CONSTRUCTION PLAN

KEEHI INTERCHANGE LANDSCAPING
(WEST OF MOANALUA STREAM)
FAIP NO. IR-HI-1(200):17

ADD. 2

SHEET No. 2 OF 20 SHEETS

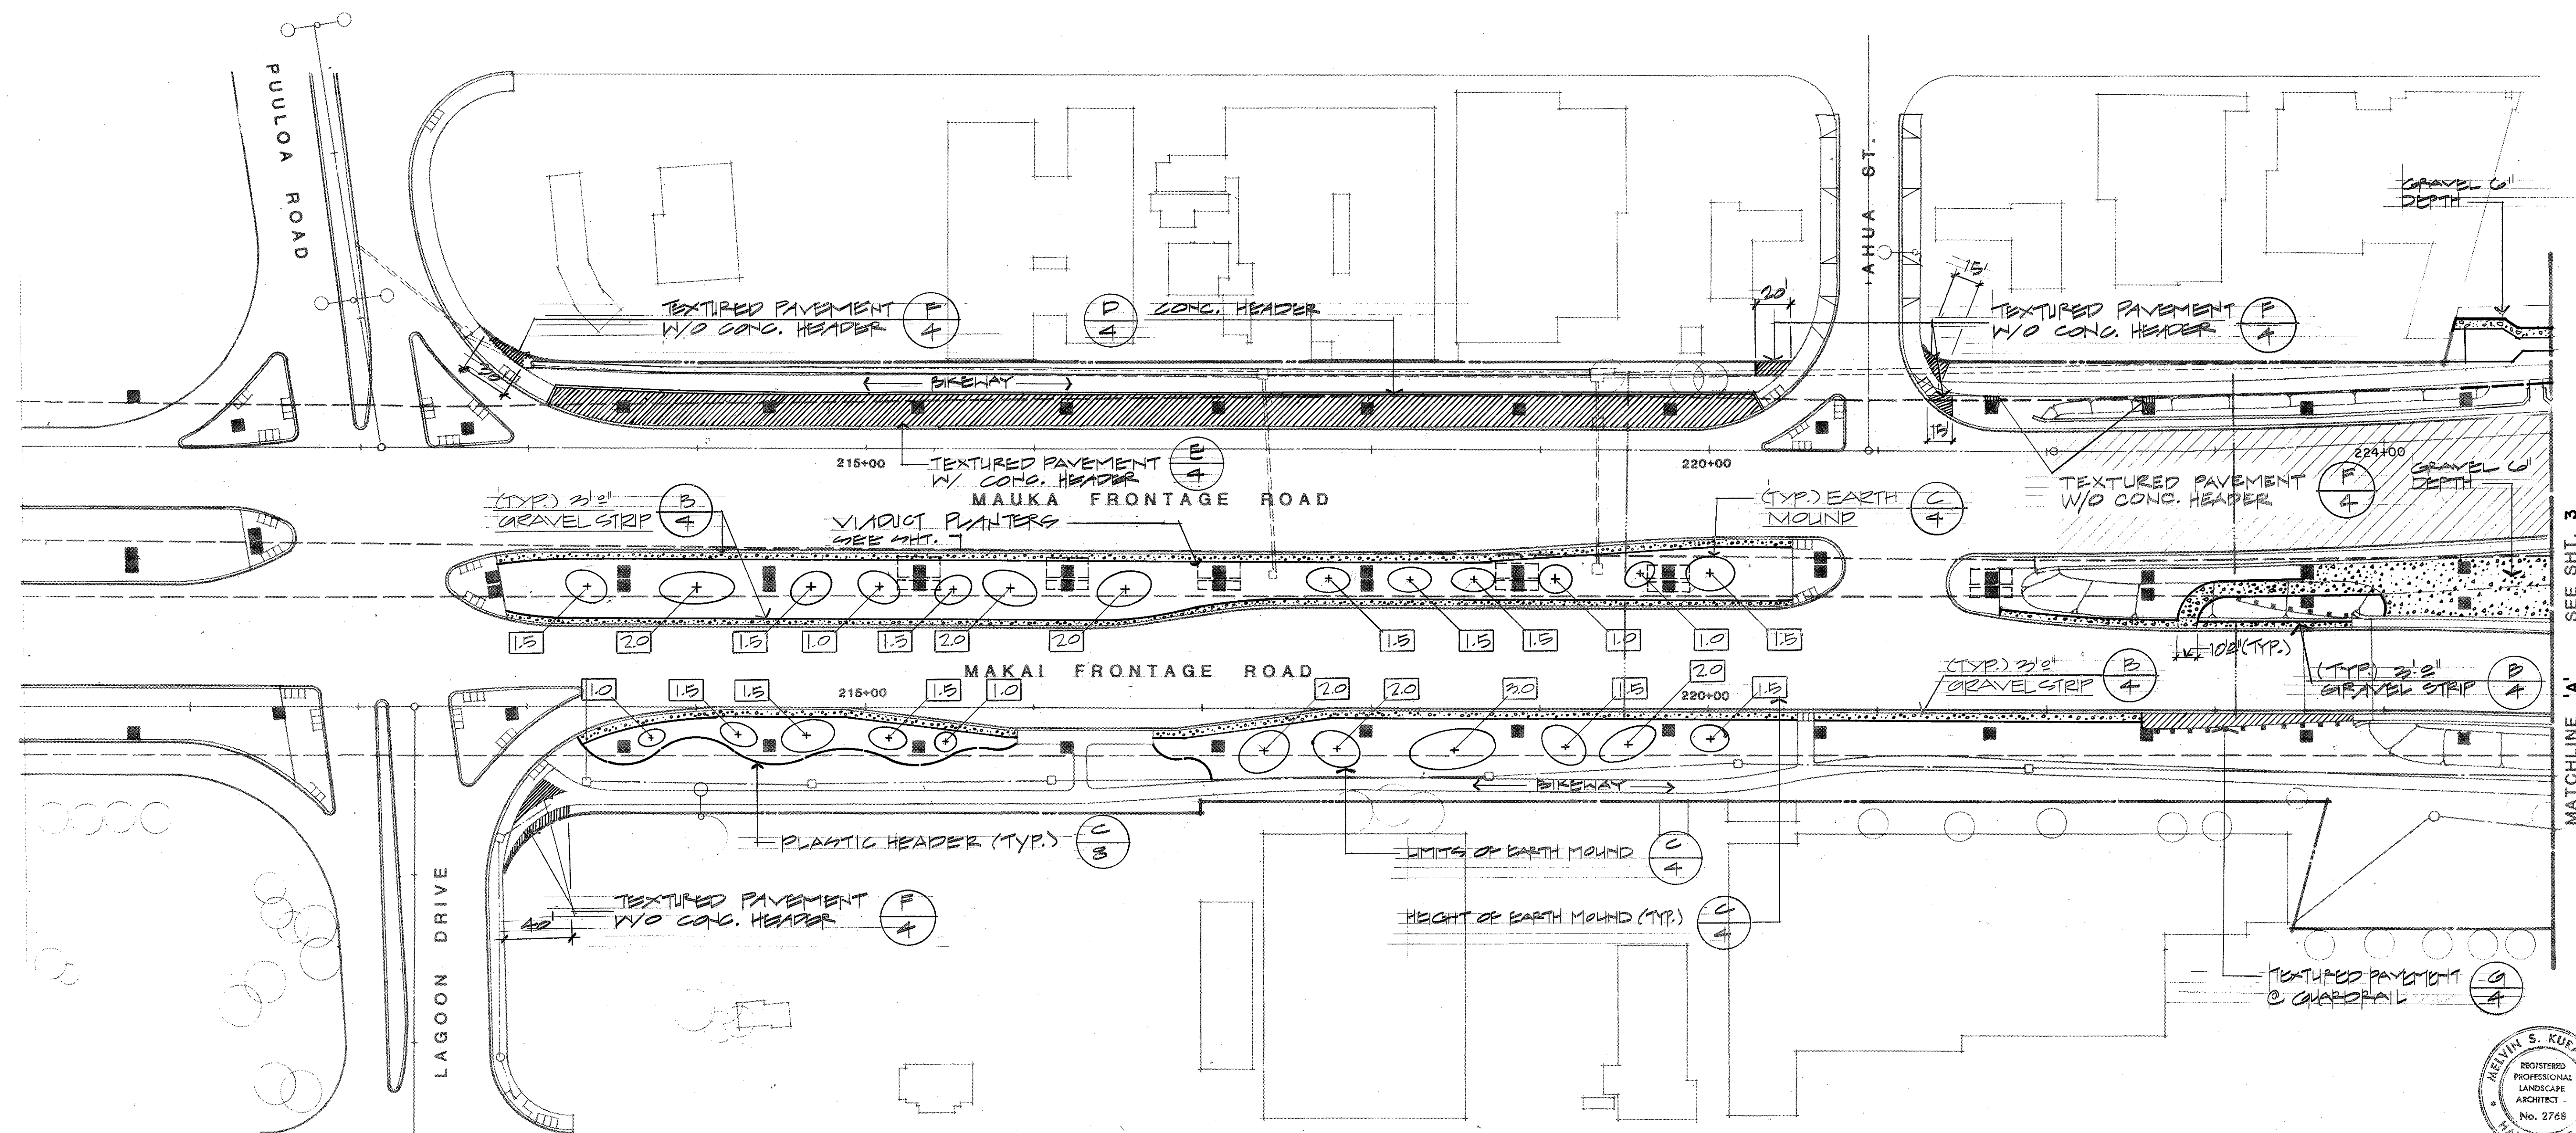
3/1/87	CHANGED LIMIT OF GRAVEL AT RIGHT-OF-WAY LINE ON MAUKA SIDE FROM STA. 224+40 TO STA. 225+00
DATE	REVISION

CONSTRUCTION PLAN
KEEHI INTERCHANGE LANDSCAPING
(WEST OF MOANALUA STREAM)
FAIP NO. IR-HI-1(200):17
SCALE: 1"=50'-0" DATE: MAY 1986
SHEET No. 3 OF 20 SHEETS

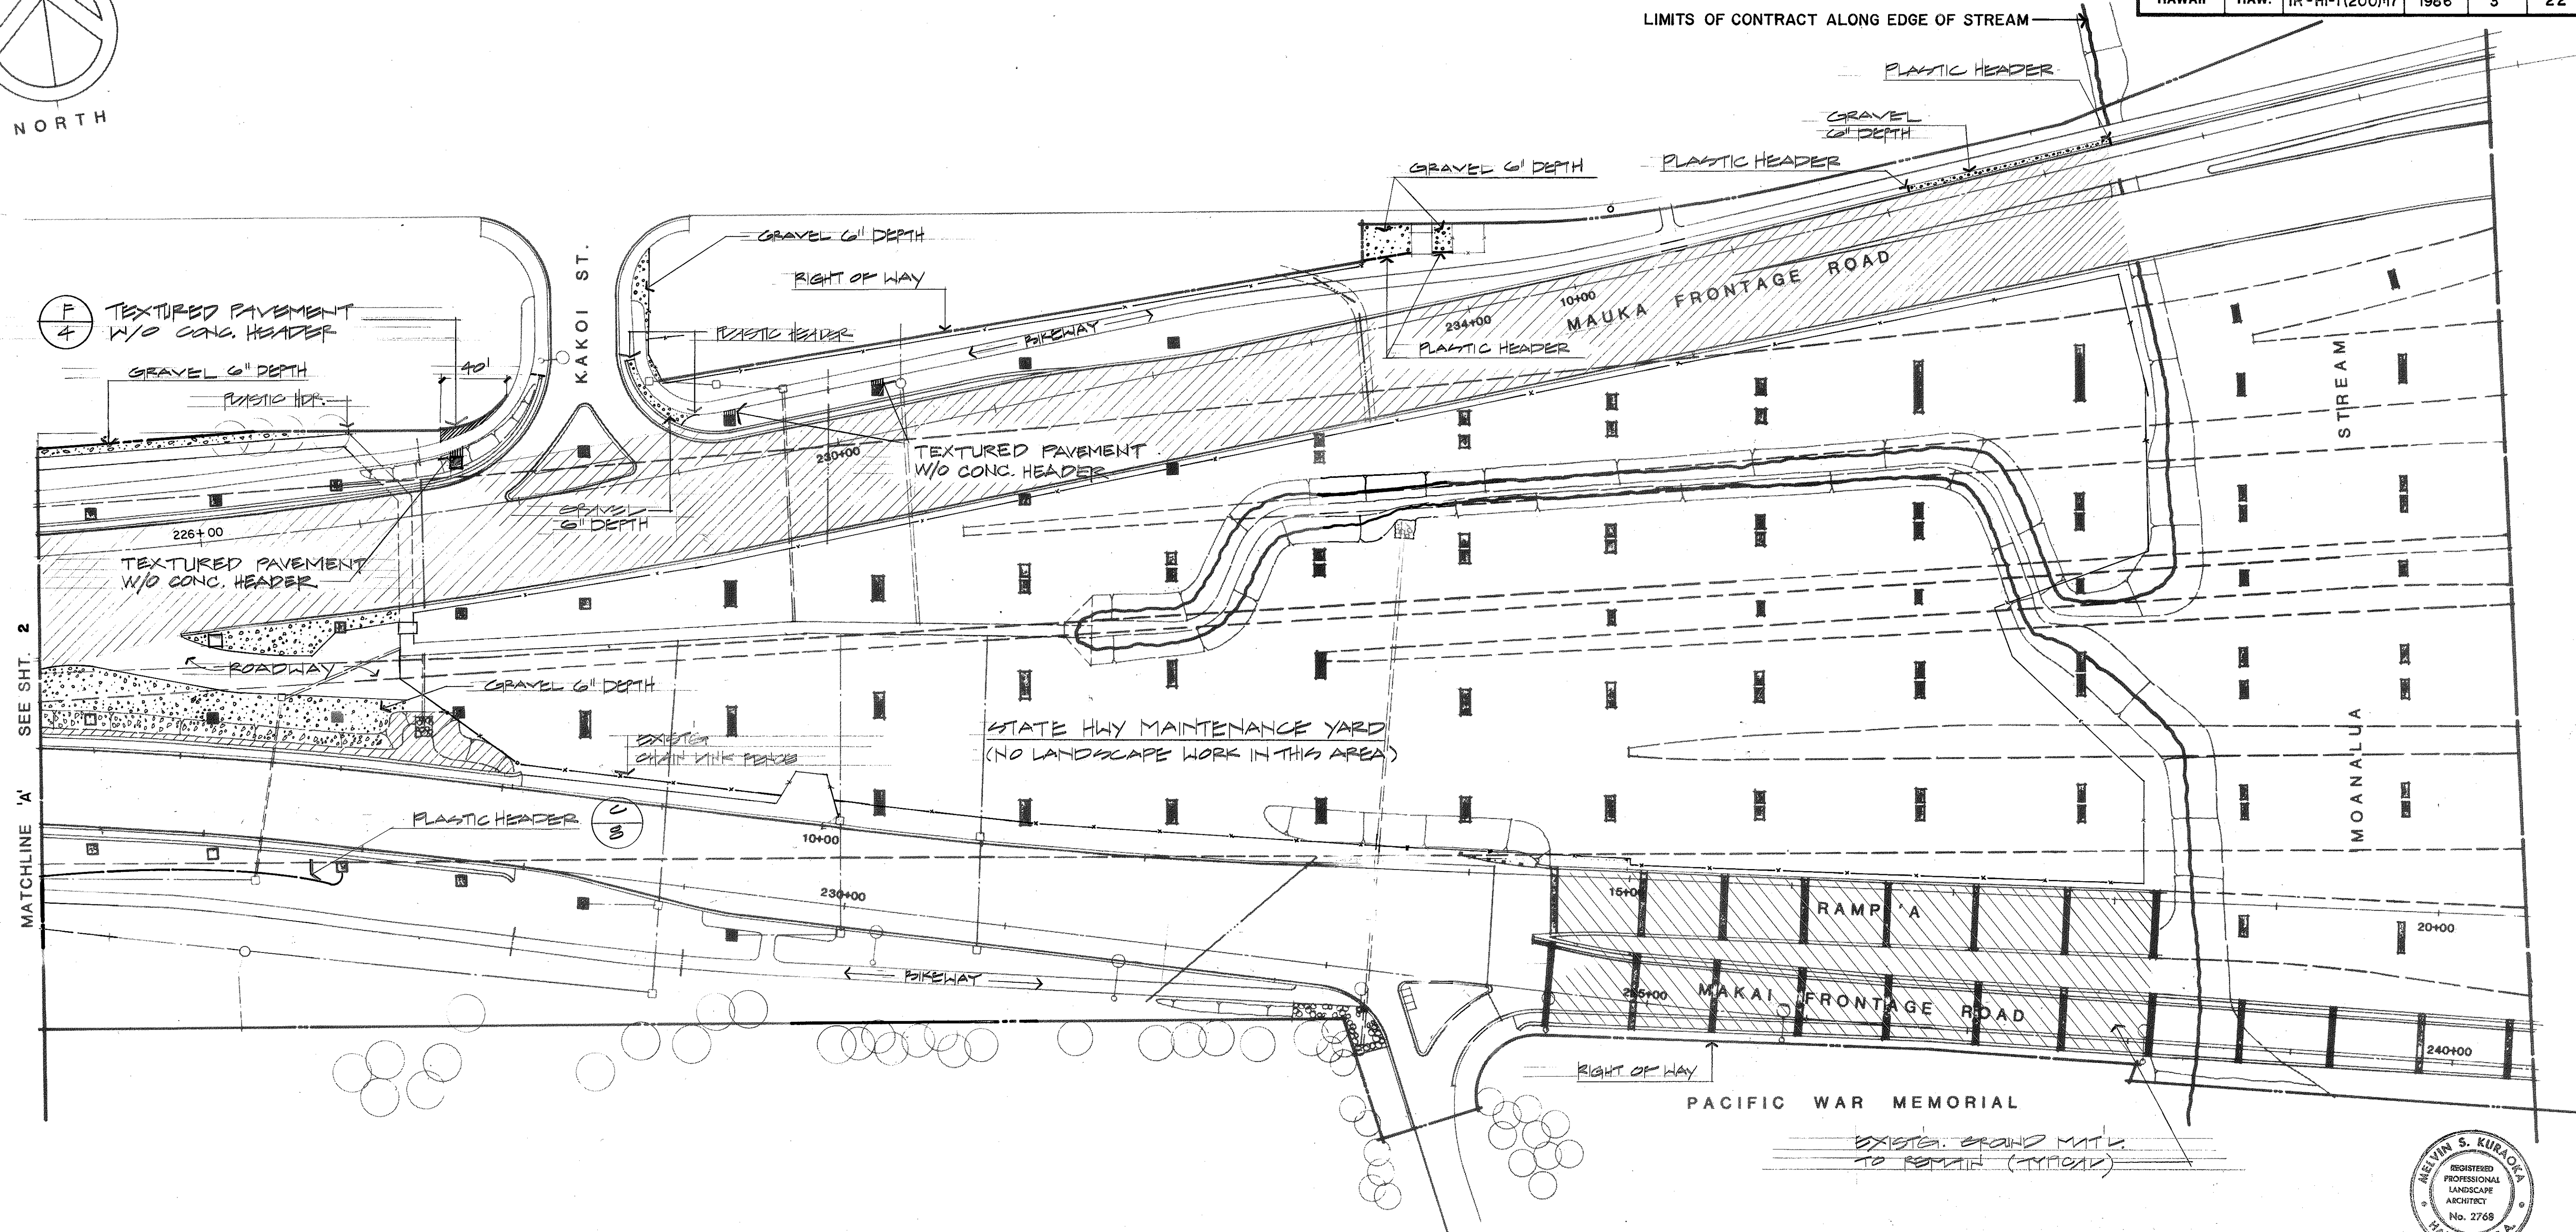
7-16-87	DELETED PLASTIC HEADER FROM STA. 226+90 TO 227+95 & TEXTURED PAVEMENT FROM STA. 232+12 TO 232+32 ON MAKAU SIDE OF MAKAU FRONTAGE ROAD.
3/1/87	CHANGED LIMIT OF GRAVEL AT RIGHT-OF-WAY LINE ON MAUKA SIDE FROM STA. 225+00 TO STA. 226+90
DATE	REVISION
